<b>CITY OF WESTMINSTER</b>			
<b>PLANNING SUB APPLICATIONS COMMITTEE</b>	<b>Date</b> 22 May 2018	<b>Classification</b> For General Release	
<b>Report of</b> Director of Planning		<b>Ward(s) involved</b> West End	
<b>Subject of Report</b>	46 Clarges Street, London, W1J 7ER		
<b>Proposal</b>	Retention of one external air handling unit within the front lightwell. Relocation of six external condensers and the installation of four new external condensers (three at mid roof level and seven at upper roof level) with associated acoustic screening. Retention of internal wall mounted air conditioning units to bedrooms 1, 2, 3, 4 and 5.		
<b>Agent</b>	Bidwells		
<b>On behalf of</b>	Fox Fabs Ltd		
<b>Registered Number</b>	16/07360/FULL 16/07361/LBC	<b>Date amended/ completed</b>	2 August 2016
<b>Date Application Received</b>	2 August 2016		
<b>Historic Building Grade</b>	II		
<b>Conservation Area</b>	Mayfair

Planning permission and listed building consent are sought for the retention, relocation and installation of external air handling units and associated screening and retention of internal wall mounted air conditioning units to five bedrooms.

Drawing 1- Proposed rear elevations

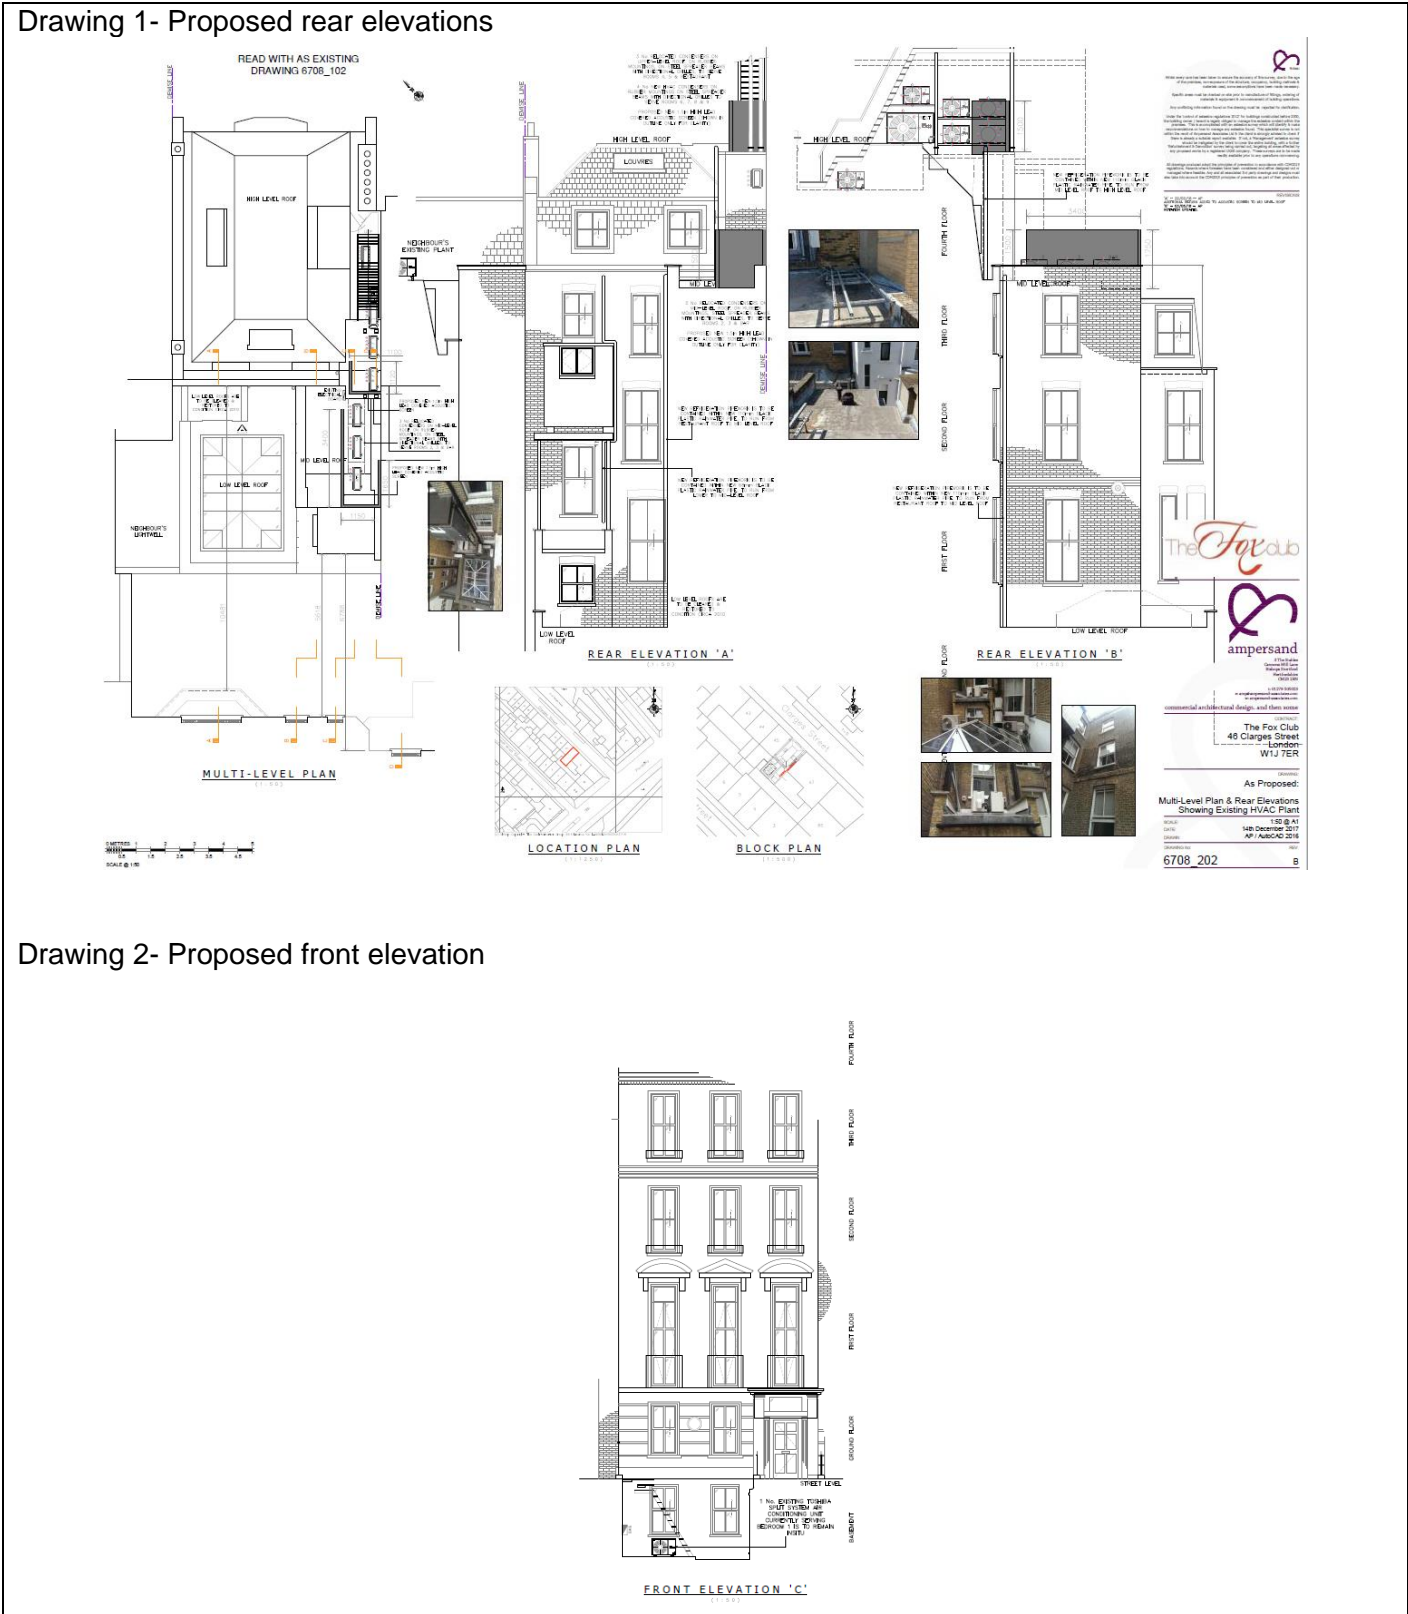
The existing unauthorised arrangement of air conditioning units at the rear of the listed building is harmful to its special interest. The proposal to relocate these at roof level in a screened enclosure improves the appearance of the rear of the building. Adding additional bulk to the rear of the closet wing is normally considered unacceptable in listed building policy terms because the height of the wing should be subordinate to the main building, and should not rise above the parapet level of the rear facade.

In this particular case, the rear of the terrace of which this building is part is very varied. The building to the south is significantly taller. The proposed plant area would be set adjacent to the higher party wall, away from the north wall of the closet wing, and the visual impact is considered acceptable. The screening is to be clad in lead, which will give it a traditional appearance. The other units fixed higher up on the party wall will also be screened. It is considered that these proposals will not harm the special architectural and historic interest of the listed building or harm the character and appearance of this part of the Mayfair Conservation Area.

The air conditioning units at third floor roof level would be approximately 9m from windows in the rear of 4 Half Moon Street. The proposed screening would be marginally closer. The screening would be directly visible in private views from both Nos. 4 and 5 Half Moon Street, although it is considered that the presence of screening would help to preserve private views. Similarly, the proposed screening to the plant at main roof level would also preserve private views. No. 5 Half Moon Street is offset and due south of the application site. As such, it would have limited views of the proposed plant and screening under the fire escape at roof level.

Drawing 3: Proposed Multi level roof plan

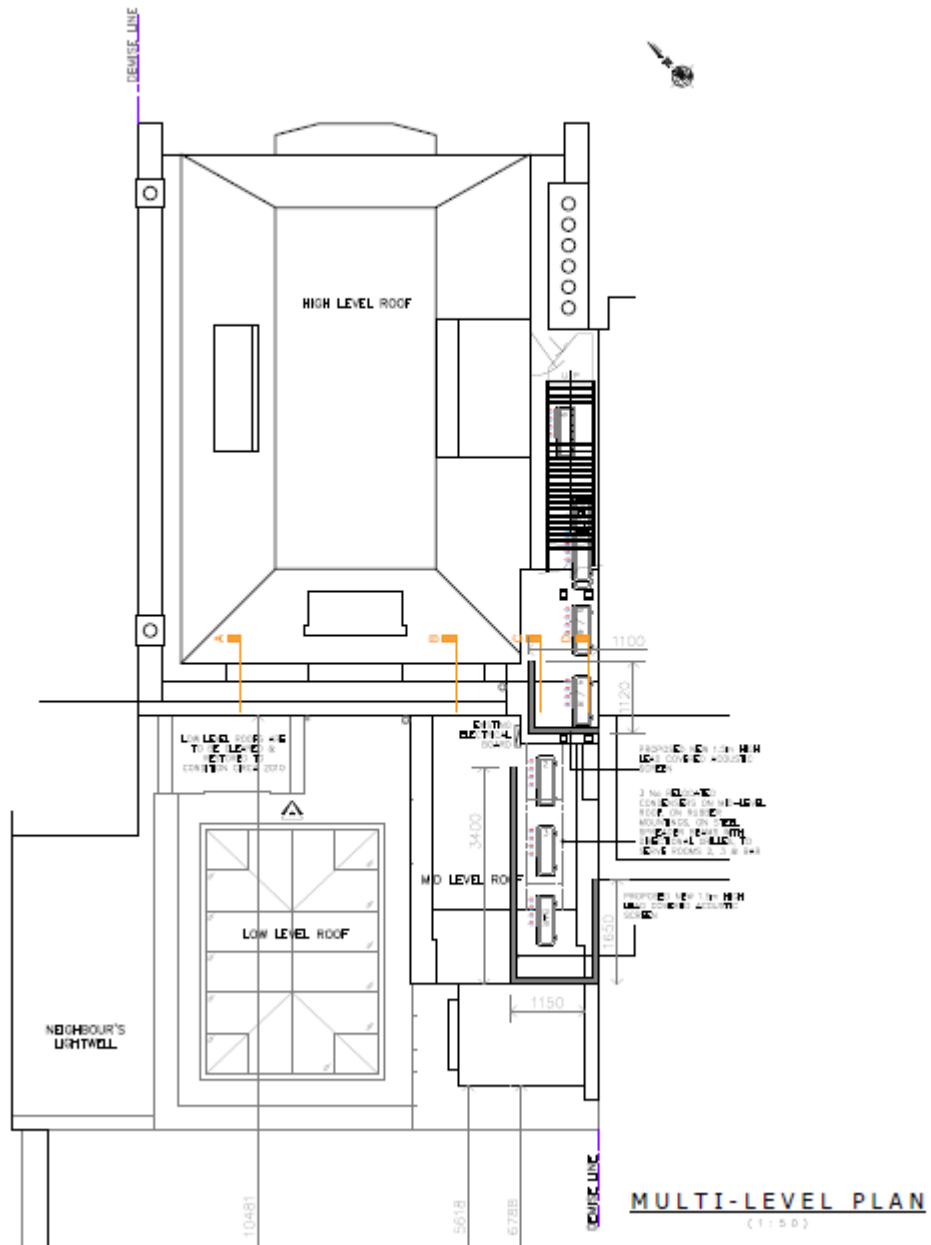
The proposal would retain an unauthorised unit within the front basement lightwell. This would be located away from neighbouring windows and would not cause harm to residential amenity. With the exception of the unit within the front basement lightwell, the proposed units would all be located / re-located to the rear of the site at third floor roof level, or at main roof level under a fire escape stair.

lead acoustic screens to both the third floor roof level and the main roof level (under the fire escape).

- 5 You must install all the screens as shown on approved drawing 6708\_202 Rev B and 6708\_204 Rev B before you use the machinery. You must then maintain the screens in the form shown for as long as the machinery remains in place.

SECTION THROUGH 'D'-'D'  
 (1:1000)

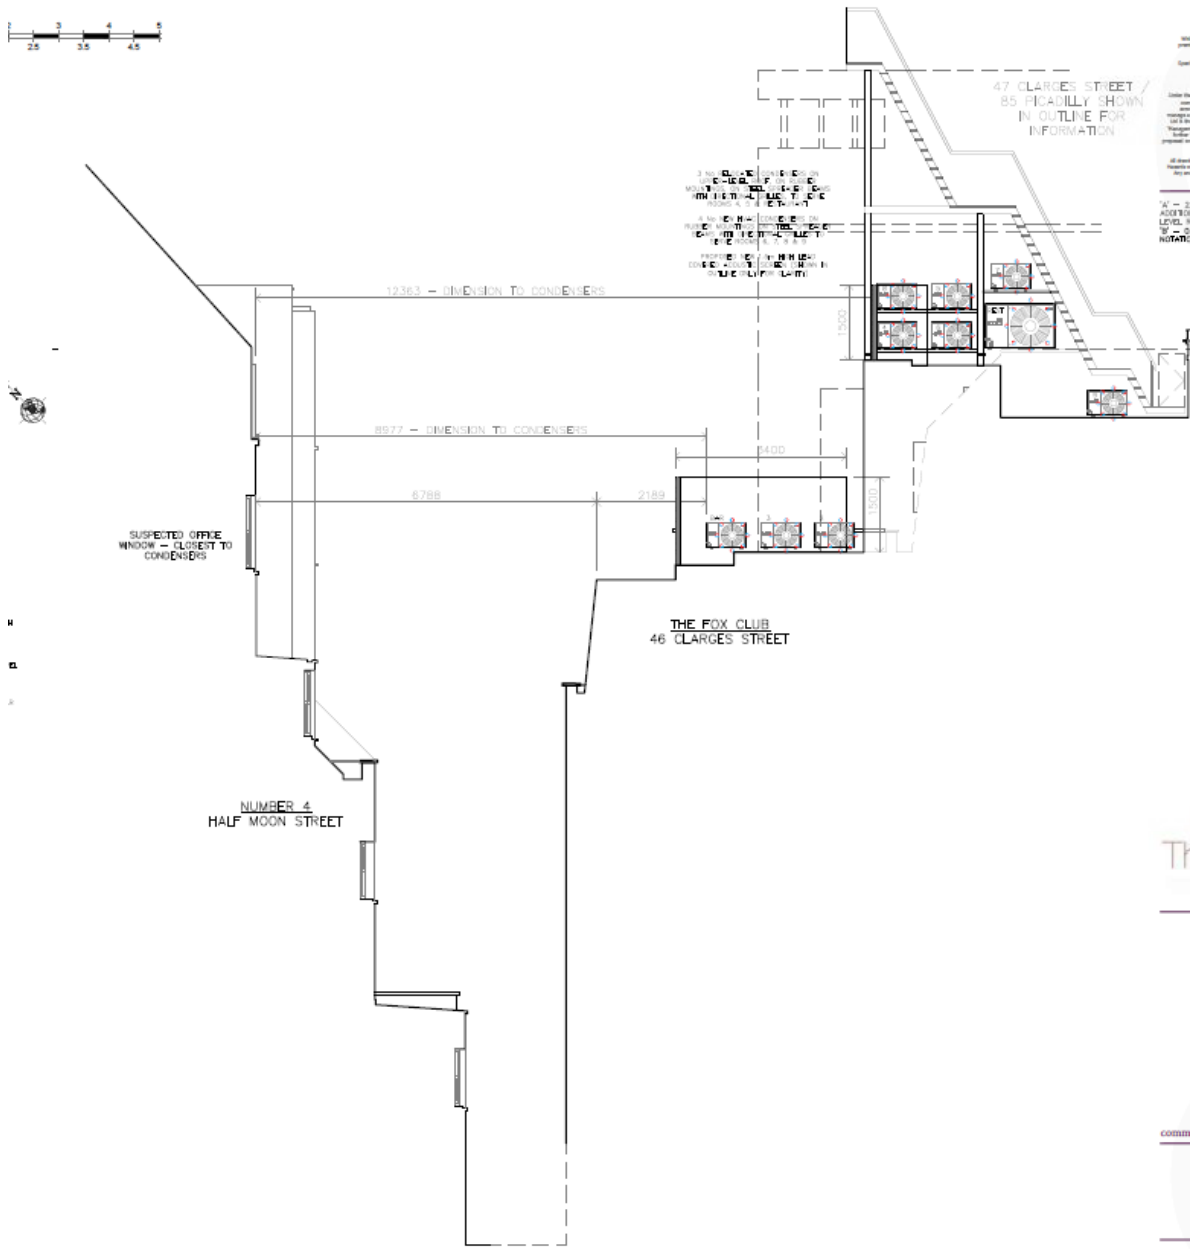
The nearest noise sensitive windows are 9m away. In order that the design criteria is achieved 1m outside the nearest residential window, the applicant is proposing to install
